19 JUNE 2019

# PARK DEVELOPMENT FOR SPRING RUN NORTH PARK

EAGLE MOUNTAIN UTAH

SHEET TITLE:  
SITE DEVELOPMENT  
PLAN  
SHEET NUMBER:  
**L101**  
LANDSCAPE

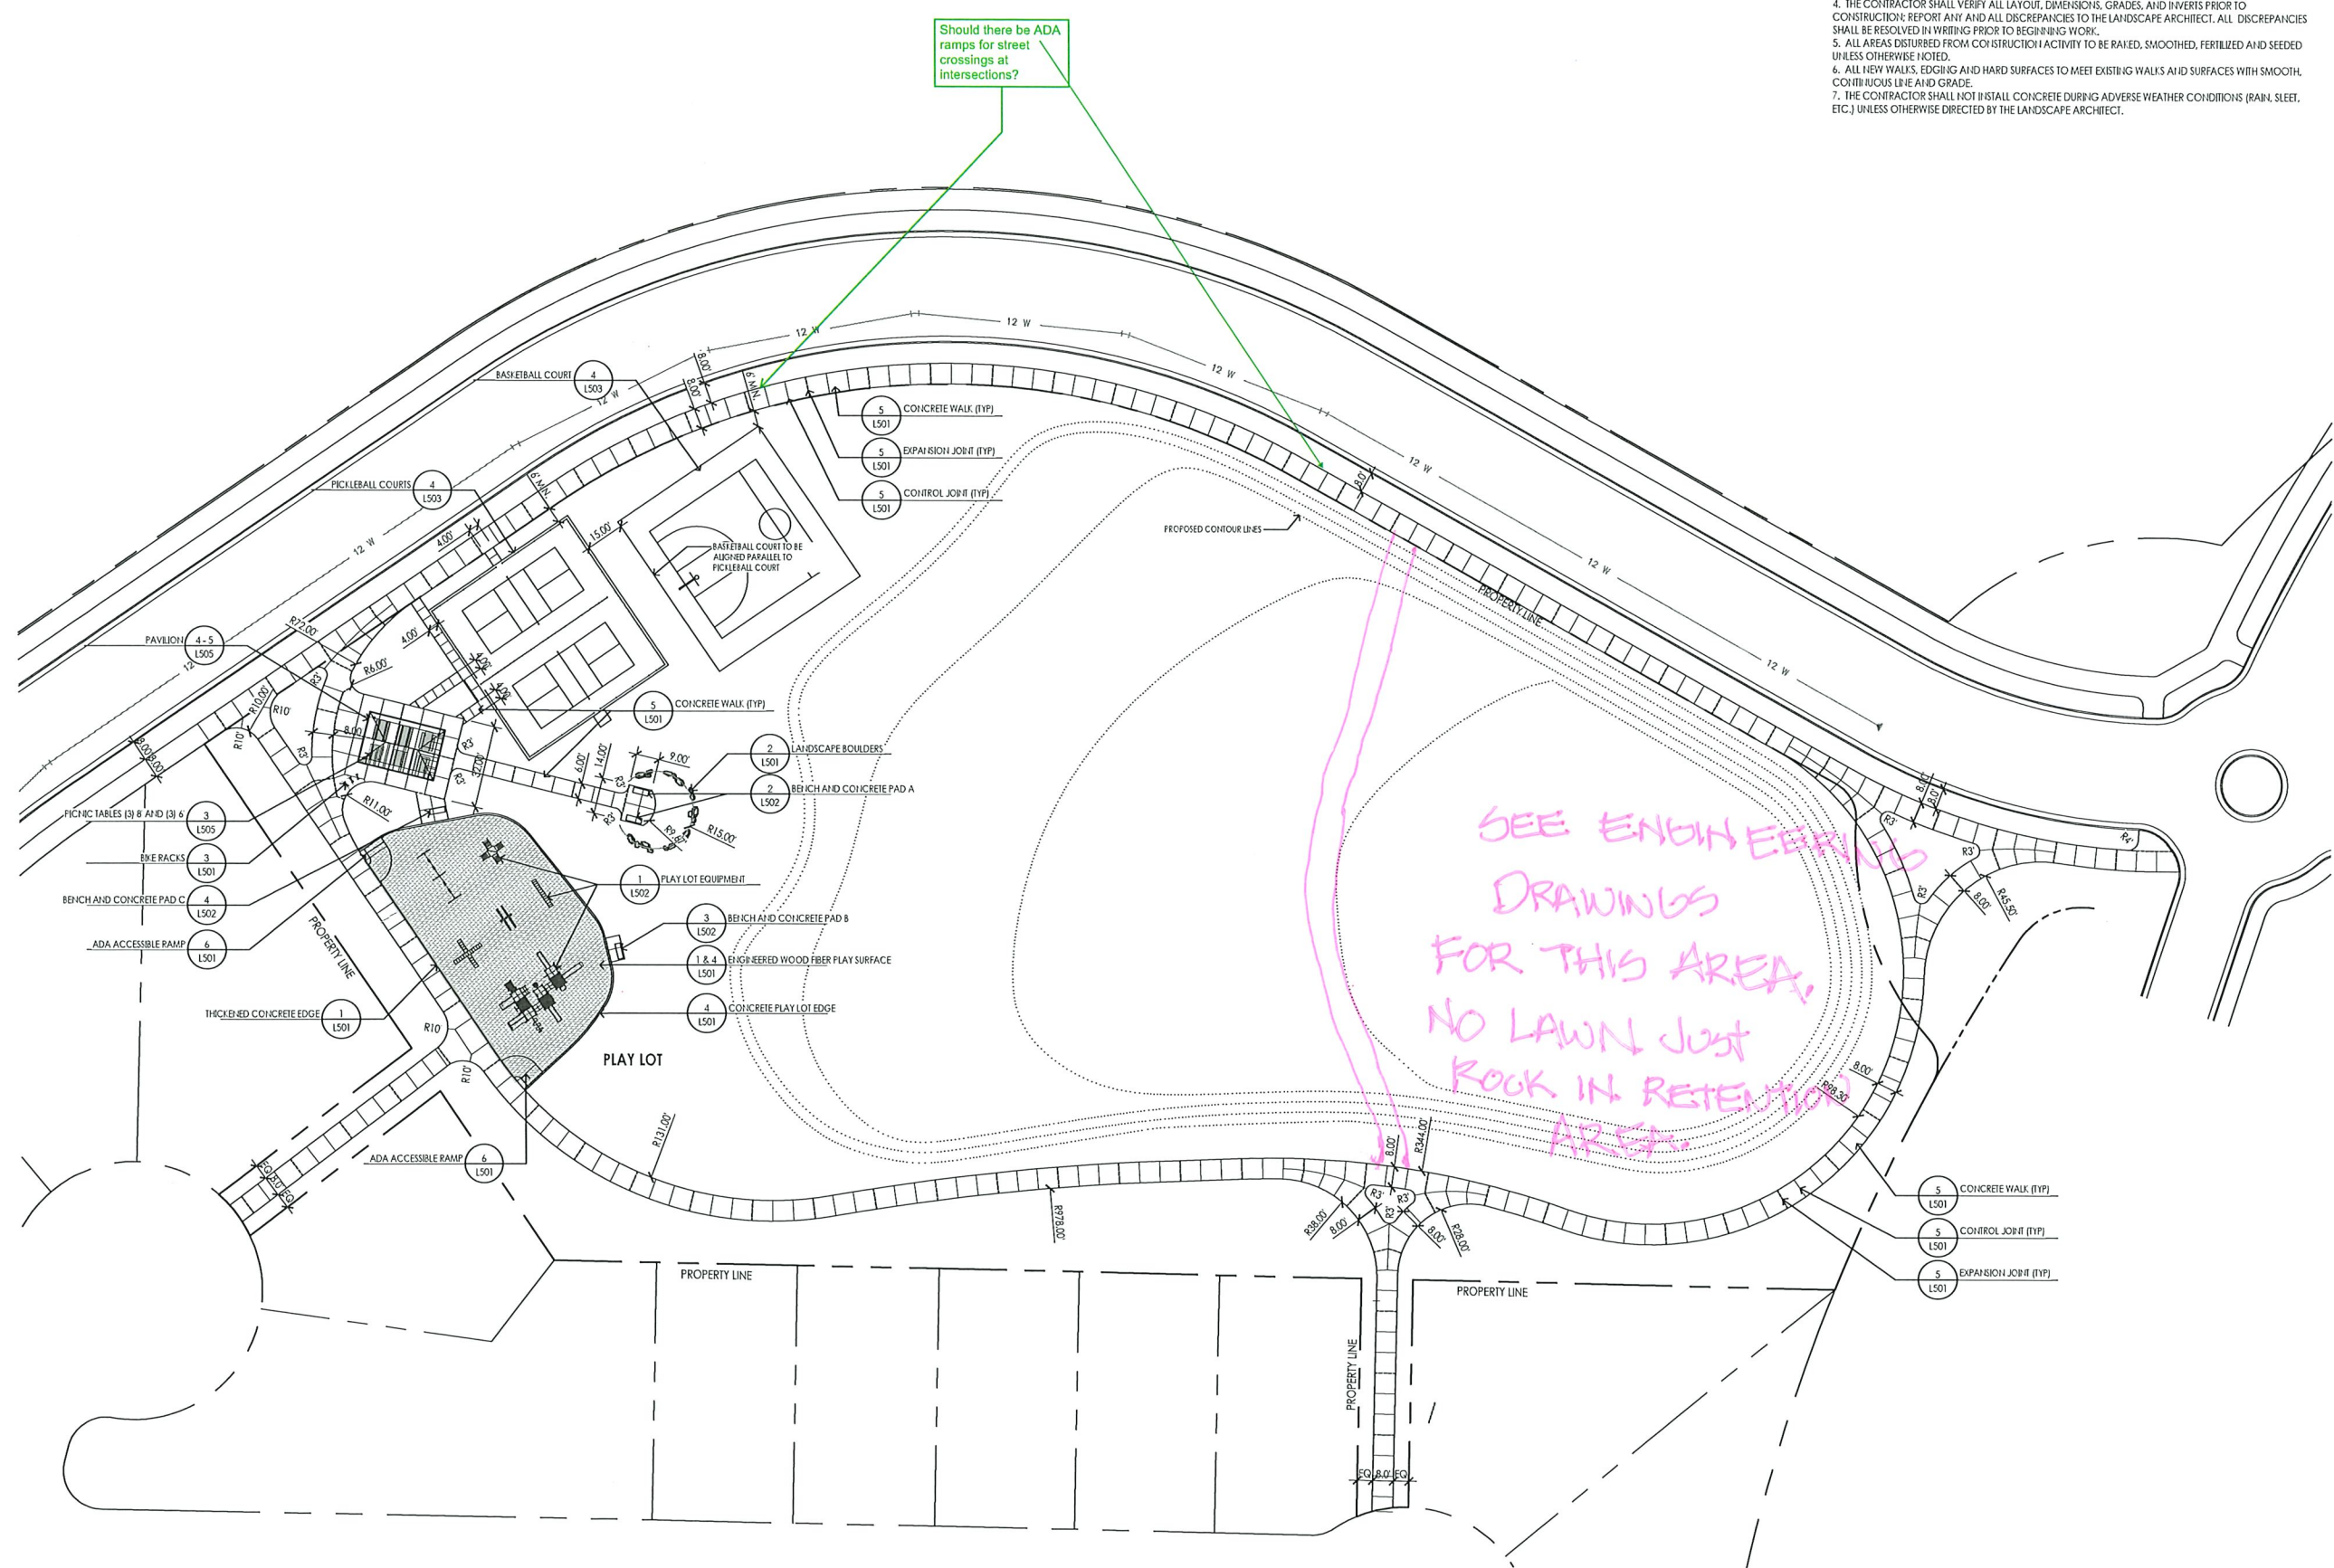
Should there be ADA ramps for street crossings at intersections?

SHEET TITLE:  
PLANTING  
PLAN  
SHEET NUMBER:

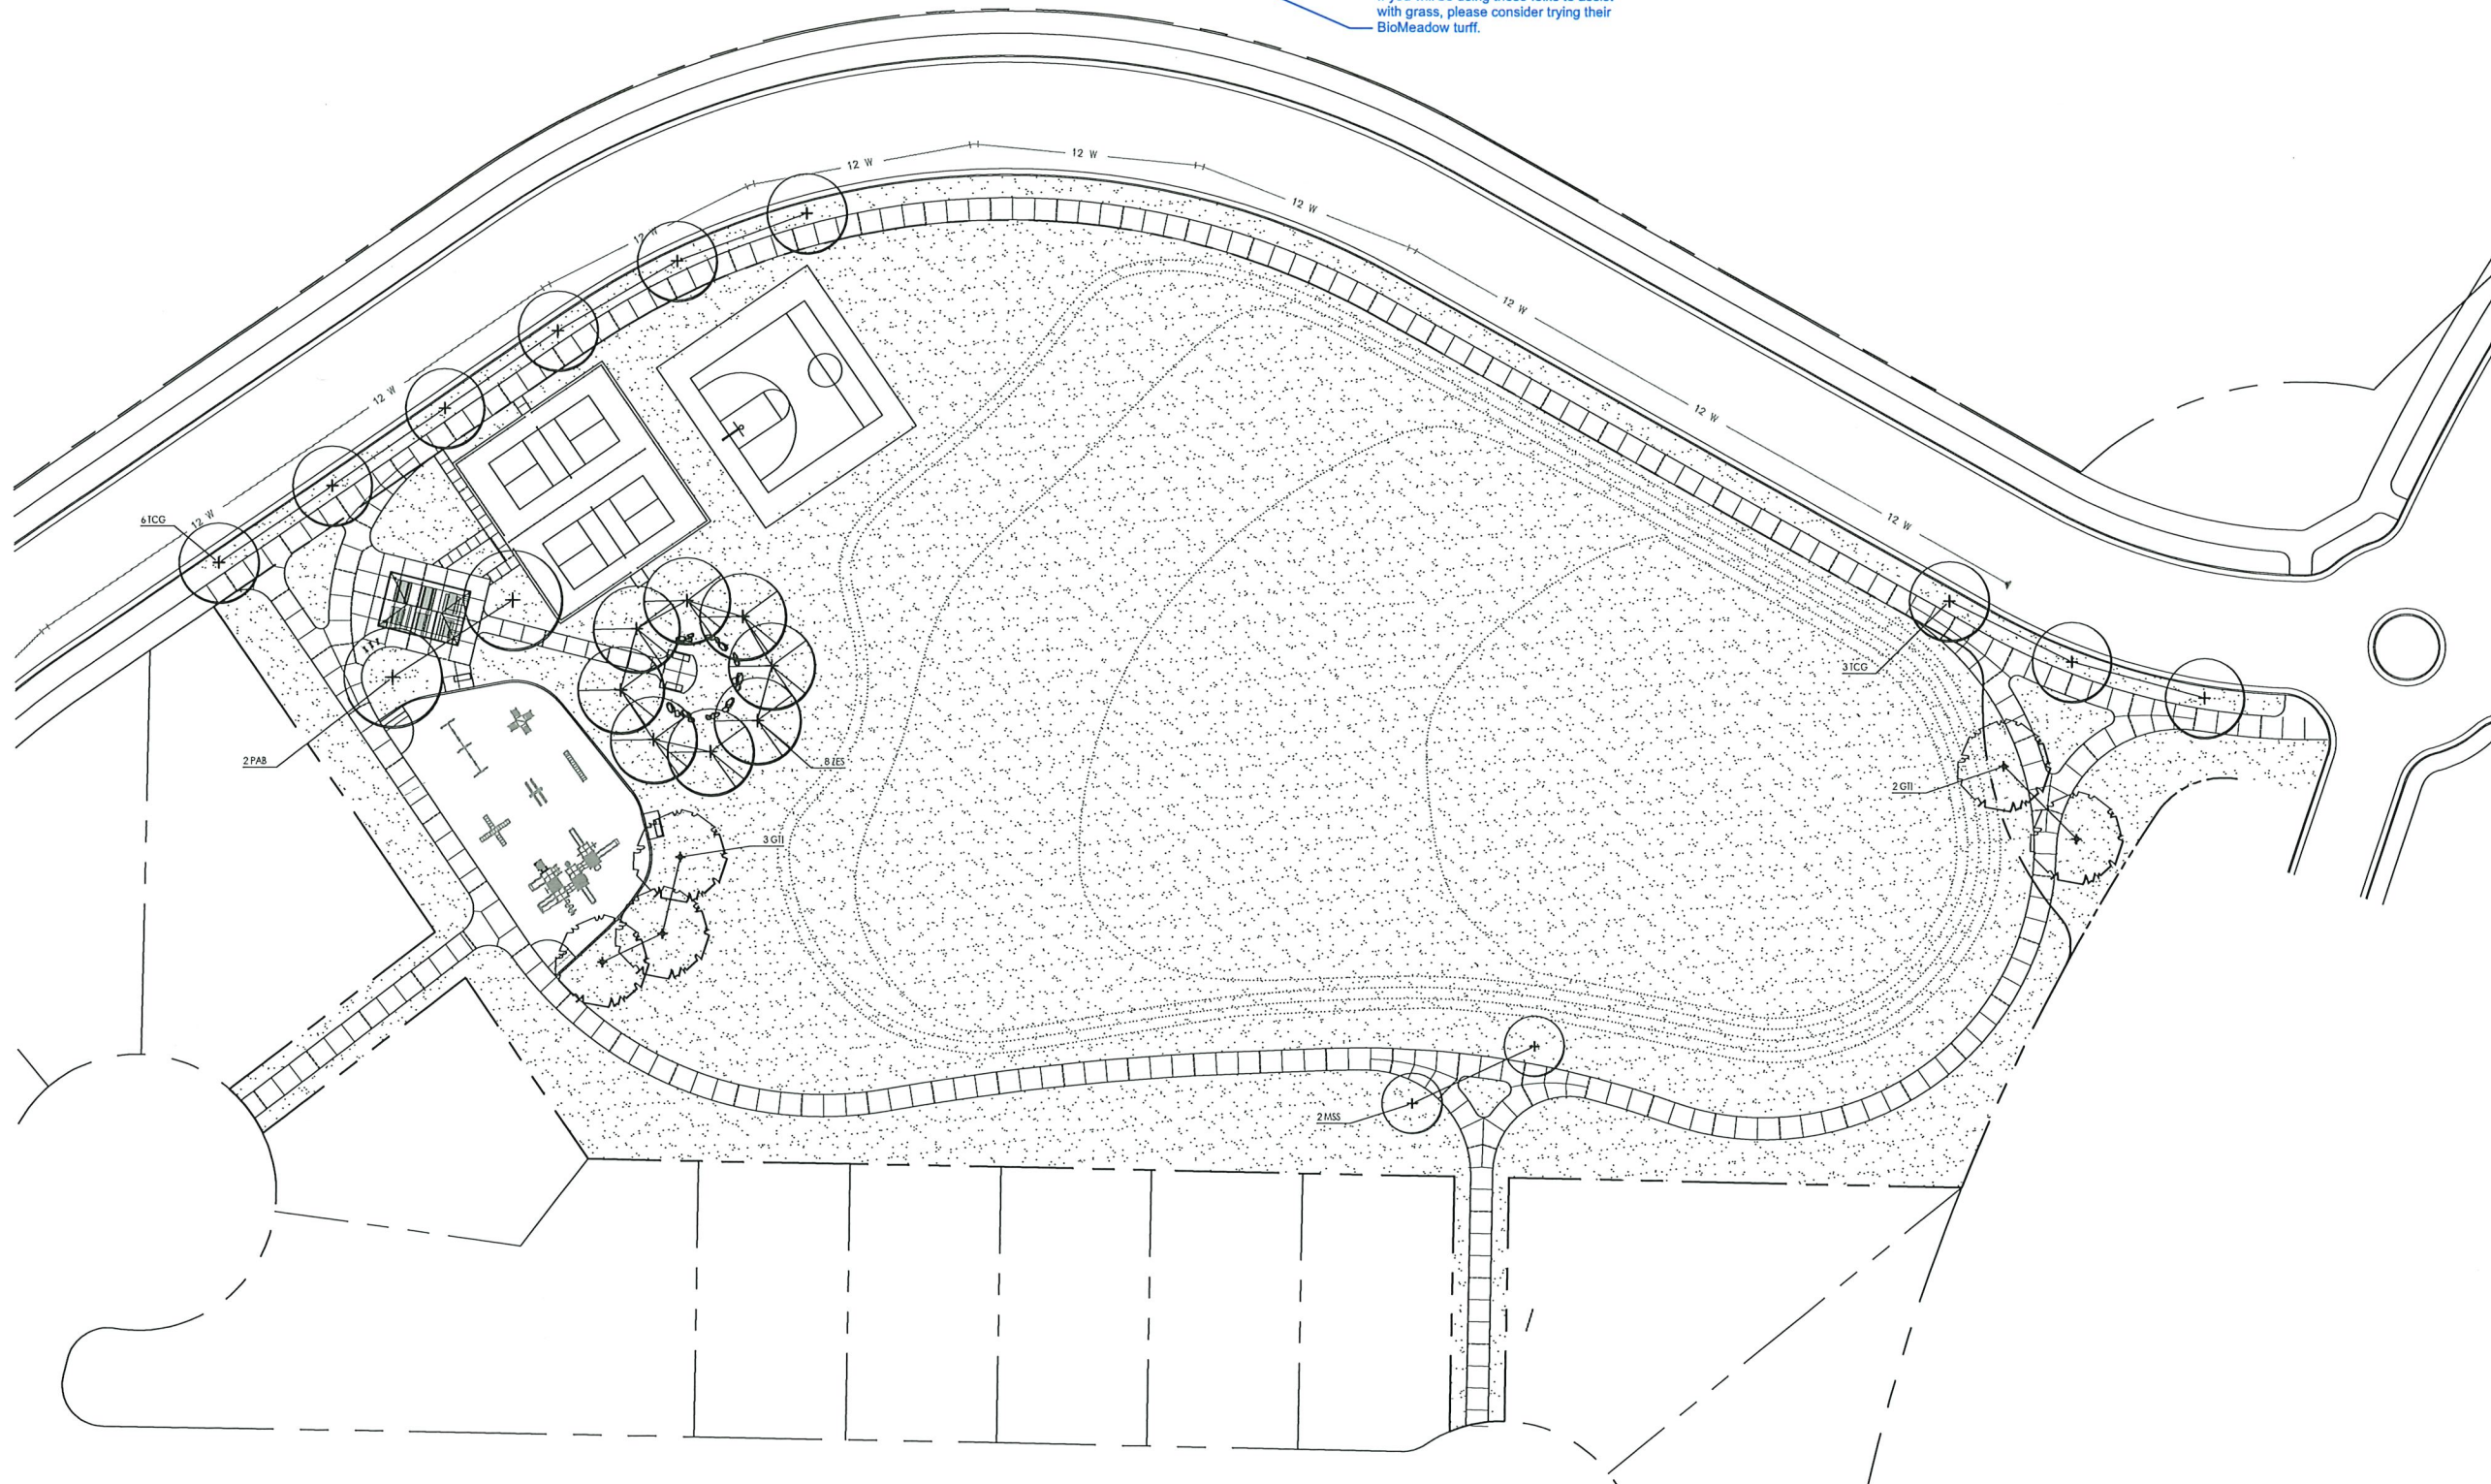
EMC is working to move to more native and drought tolerant plants and grasses. Please send tblack@emcilly.org an email if you are interested in assist us in taking steps to reduce our water needs. Many of these will require little to no water to persist in EMC.

If you will be using these folks to assist with grass, please consider trying their BioMeadow turf.

**TIMER SWITCH POST** 1  
NOT TO SCALE

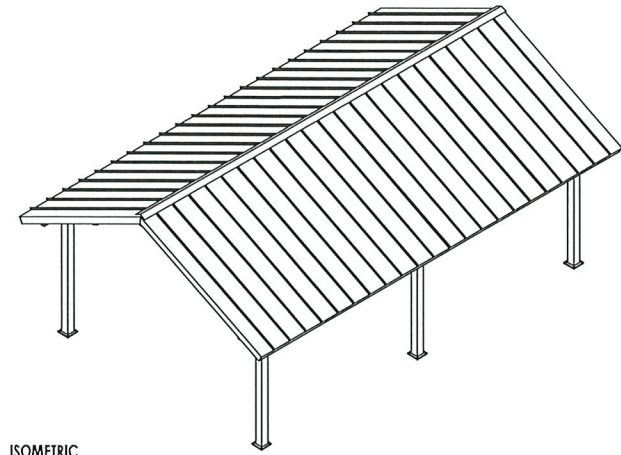
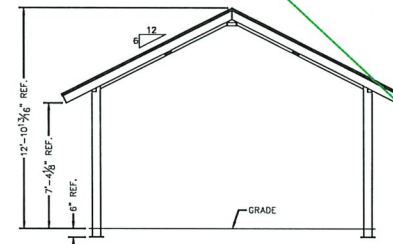
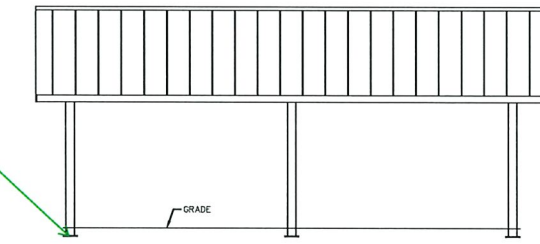
Will post be bolted to footings under concrete pad? Needs to have diamond cut-out on concrete pad around post.
